**Evaluation of Regulations for  
the Expansion of the Flower  
Garden Banks National Marine  
Sanctuary Expansion**

**White Paper**

**October 2016**

**Figure 16.** Elvers Bank: existing HAPC (hatched lines) and proposed expansion (outlined in purple).

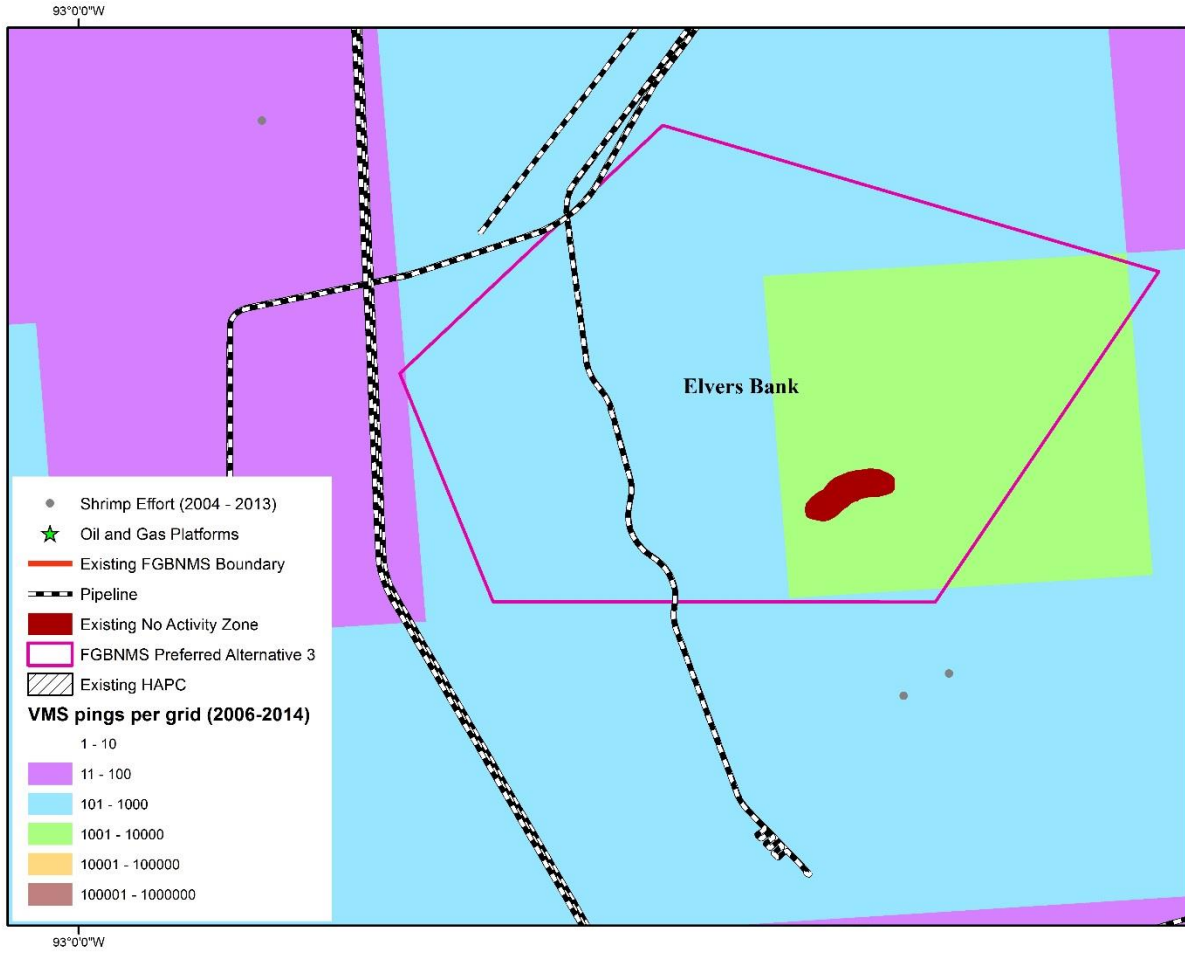
Elvers Bank is not currently designated as an HAPC (Figure 16). The green box in Figure 16 is an area of high usage by the reef fish fishery and this historic fishing practices should be incorporated into the regulations considered for the FGBNMS expansion. All recommendations are based on Figure 16.

- Continue to allow historic fishing practices in the area highlighted in green in the southeast section by the following:
  - Establish a truncated “no bottom tending gear zone (including anchors)” for Elvers Bank that coincides with the established BOEM “no activity zone” established
  - Prohibit trawling within the boundaries of the proposed expansion of FGBNMS
  - Allow anchoring by fishing vessels over soft sediment (anchors used should be specific to anchoring in soft sediment (e.g. Danforth anchors, etc) as long as this area is not in the “no bottom tending gear zone”
  - Allow historic fishing practices in the area to continue as long as they comply with the bottom tending gear regulations and have a FGBNMS endorsement

**Figure 17.** Bouma Bank, Bryant Bank, Rezak Bank and Sidner Bank: existing HAPC (hatched lines) and proposed expansion (outlined in purple).

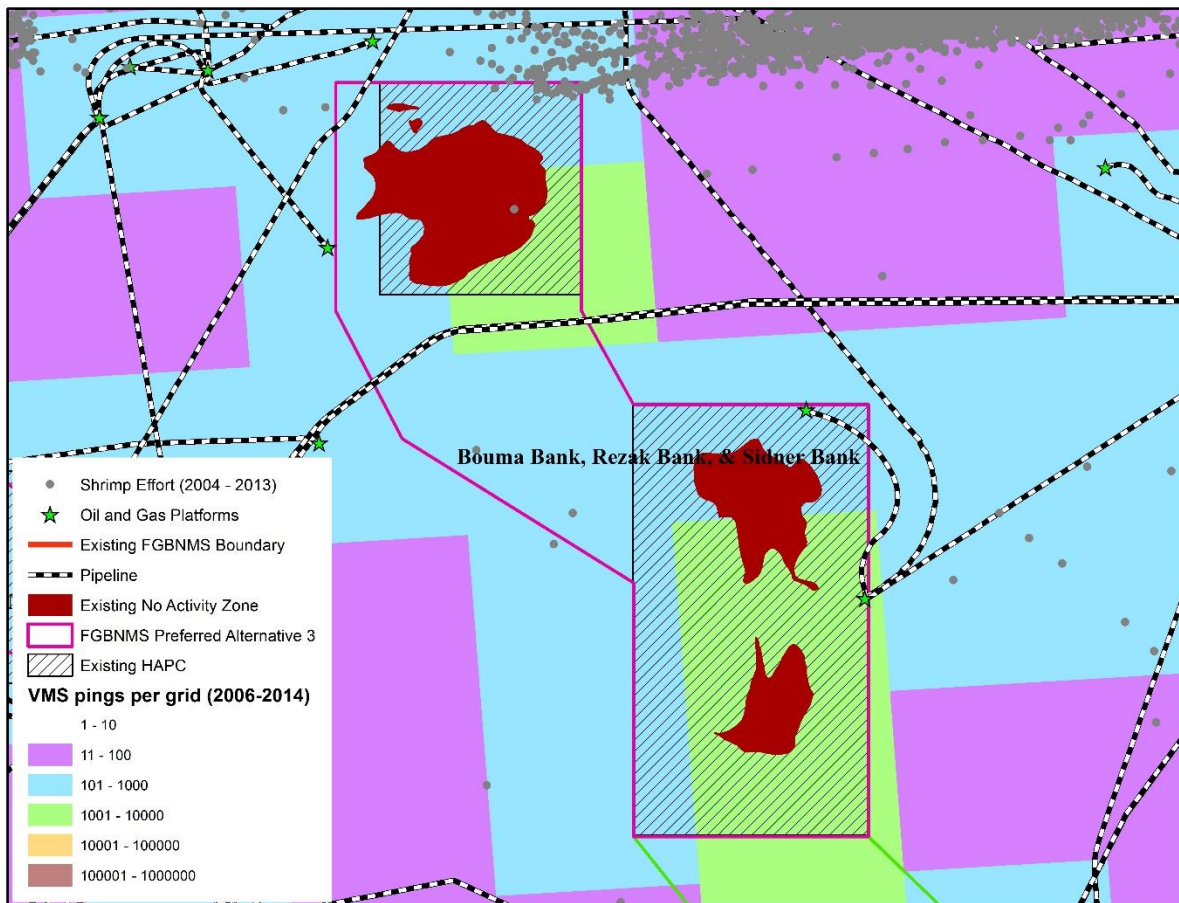
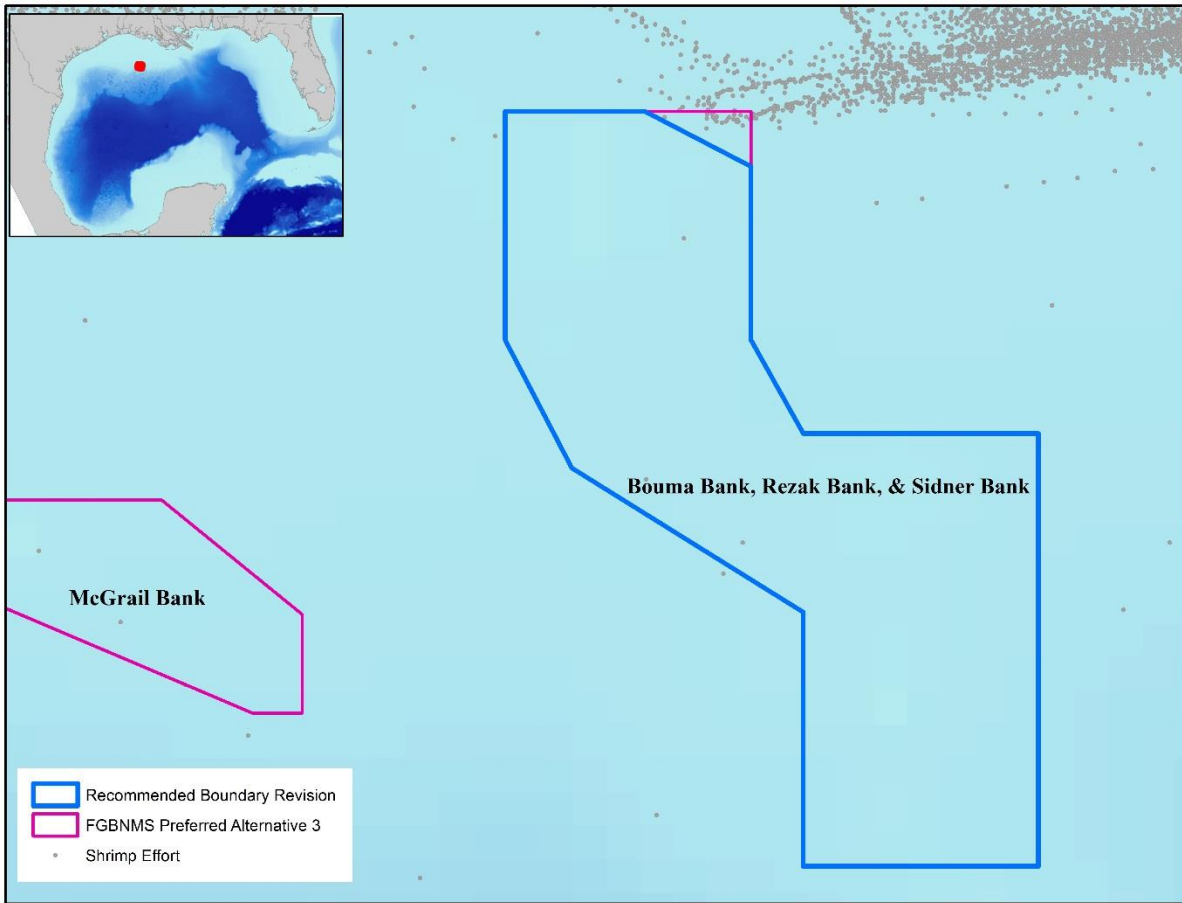
Bouma, Bryant, Rezak and Sidner Banks (Bouma Bank Complex) are designated as HAPCs but have no fishing regulations (Figure 17). The green boxes in Figure 17 are areas of high usage by the reef fish fishery and this historical fishing should be incorporated into the regulations considered for the FGBNMS expansion. Additionally, the shrimp fishery heavily uses the northern portion of the proposed boundary; the Council has already made recommendations to the FGBNMS about revising the boundary to allow for historical usage (Figure 18). All recommendations are based on Figure 17.

- Continue to allow historic fishing practices in the area highlighted in green in the southeast section by the following:
  - Establish a truncated “no bottom tending gear zone (including anchors)” for the Bouma Bank Complex that coincides with the established BOEM “no activity zone” established
  - Prohibit trawling within the boundaries of the proposed expansion of FGBNMS
  - Allow anchoring by fishing vessels over soft sediment. Anchors used should be specific to anchoring in soft sediment (e.g. Danforth anchors, etc) as long as this area is not in the “no bottom tending gear zone”
  - Allow historic fishing practices in the area to continue as long as they comply with the bottom tending gear regulations and have a FGBNMS endorsement

**Figure 20.** Example of using the BOEM “no activity zone” to delineate a “no bottom tending gear zone.”

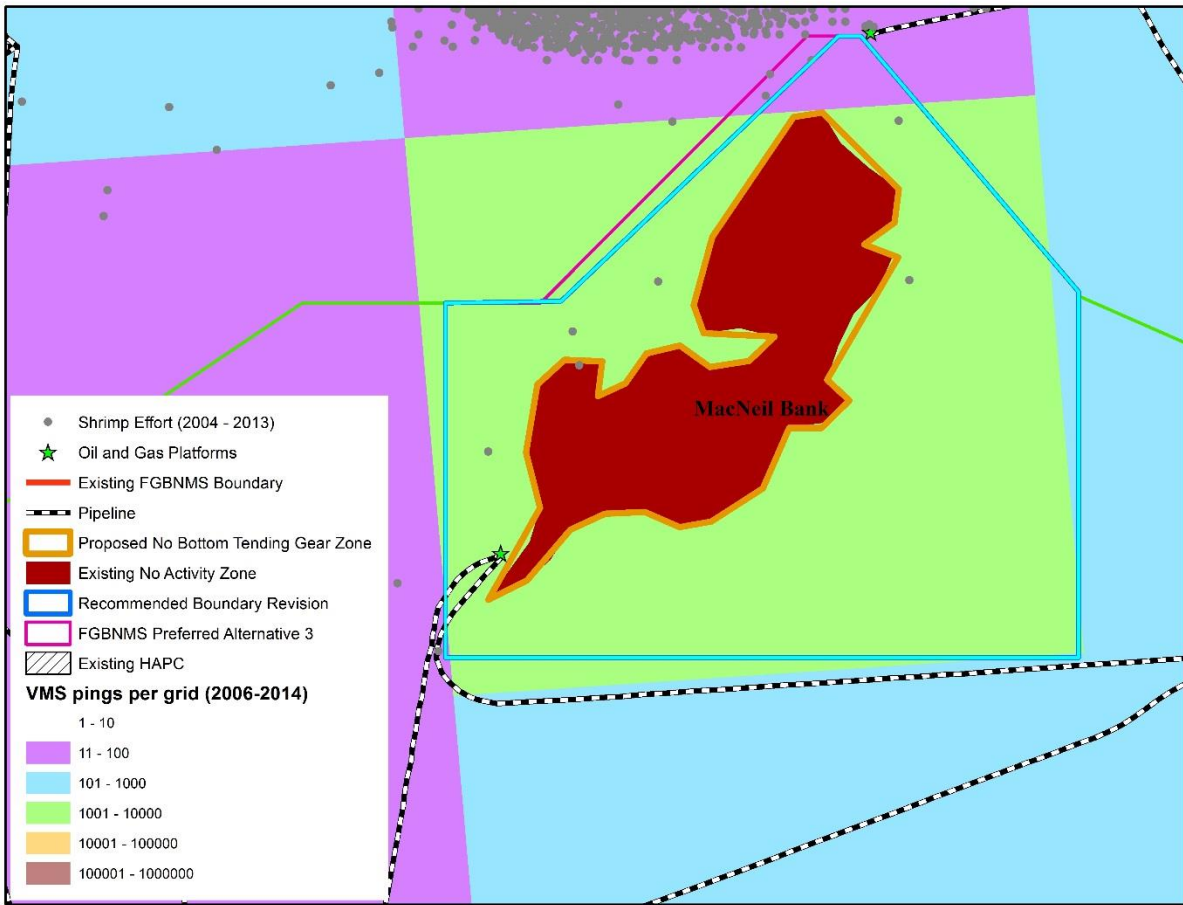
Many of the recommendations stem from having a “tiered” approach, or certain fishing activities allowed within the expansion of the FGBNMS. As it was suggested that the BOEM “no activity zones” coincide with the “no bottom tending gear zones” (Figure 20). Nearly the entirety of the proposed boundary of the Preferred Alternative 3 expansion of FGBNMS of MacNeil Bank is a heavily used area for reef fish (VMS data.) Thus, the closure of this area would greatly affect the fishermen in this region. Supporting a “no bottom tending gear zone” within the boundary while allowing anchoring in soft sediment or fishing with bottom tending gear outside of the no activity zone would minimally affect the fishermen that rely on these areas while maximizing protection for the hardbottom reef resources. Additionally, limiting the footprint of trawling outside of these areas will protect the reef from sediment plumes.

Tier 1- inside the “no bottom tending gear zones

Fishing only by hook and line, no anchoring

Requires a special endorsement from the FGBNMS

Tier 2- outside the “no bottom tending gear zone” and inside the Council recommended boundary of the expansion of FGBNMS for MacNeil Bank (Preferred Alternative 3)

Anchoring using a soft sediment specific anchor (e.g. Danforth anchors, etc)

No bottom trawling, traps, or dredges

Tier 3- outside of the proposed boundary

No FGBNMS imposed regulations (all regulations that currently exist are maintained)
